Cherwell Street, Banbury: Bus service improvement scheme

Report of March 2024 consultation

Issue date: August 2024

Features of the proposed scheme

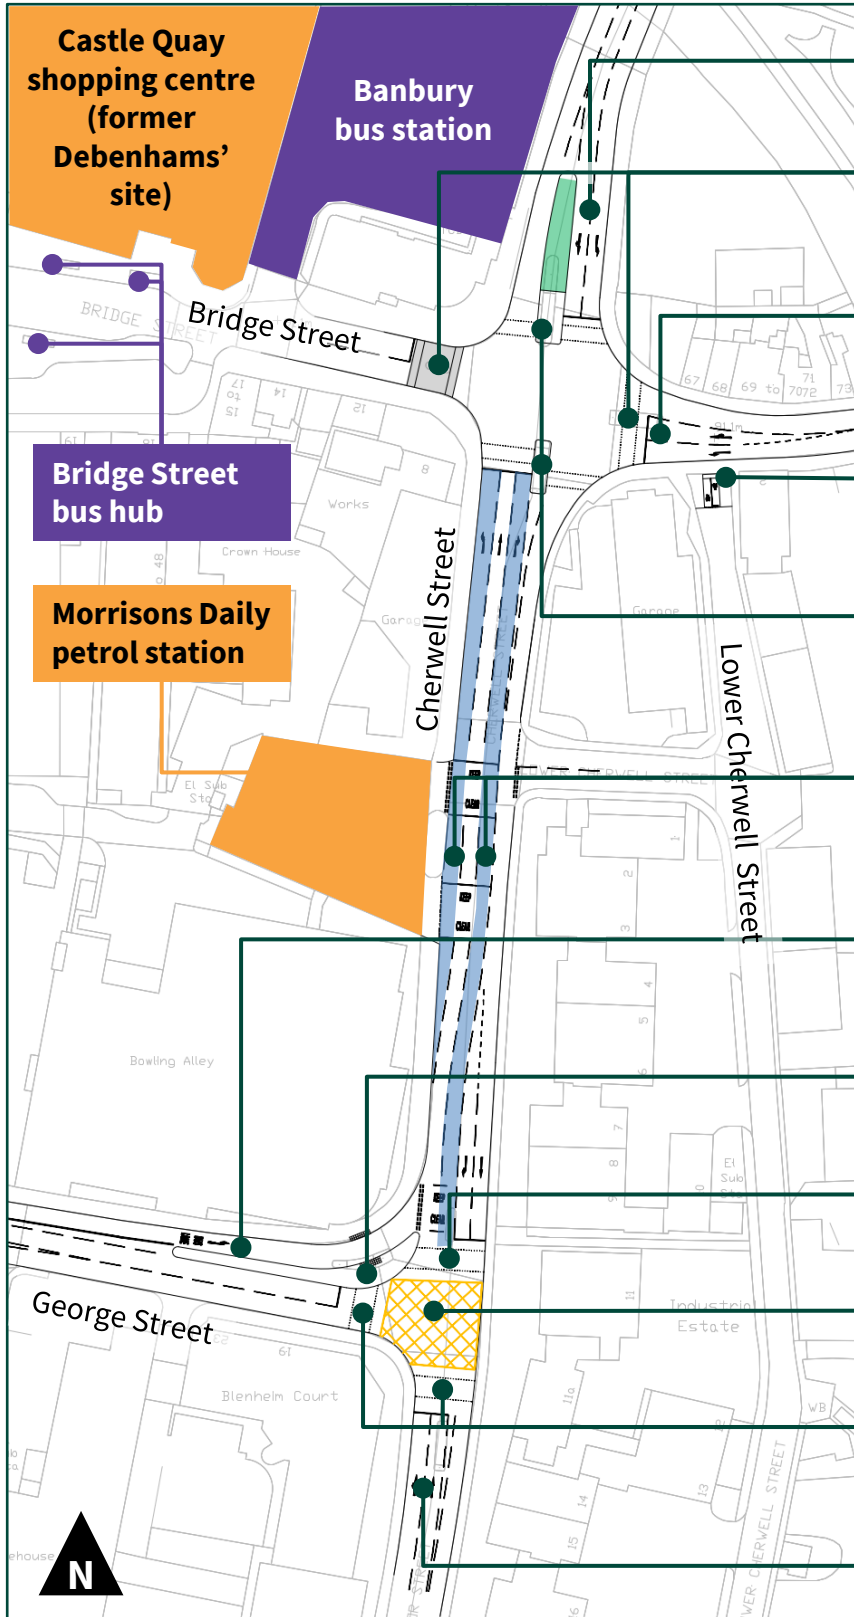
<p>Reconstruction and expansion of pedestrian island: Strongly approve</p>	Noted.
<p>New pedestrian crossing: Strongly approve</p>	Noted.
<p>Repainted yellow box junction: Strongly approve</p>	Noted.
<p>Improved pedestrian crossings: Strongly approve</p>	Noted.
<p>Approve of plans to speed access of buses to bus station from Concord Ave as currently waiting time for right turn is very long</p>	<p>This feedback will be considered in the next stage of design.</p>
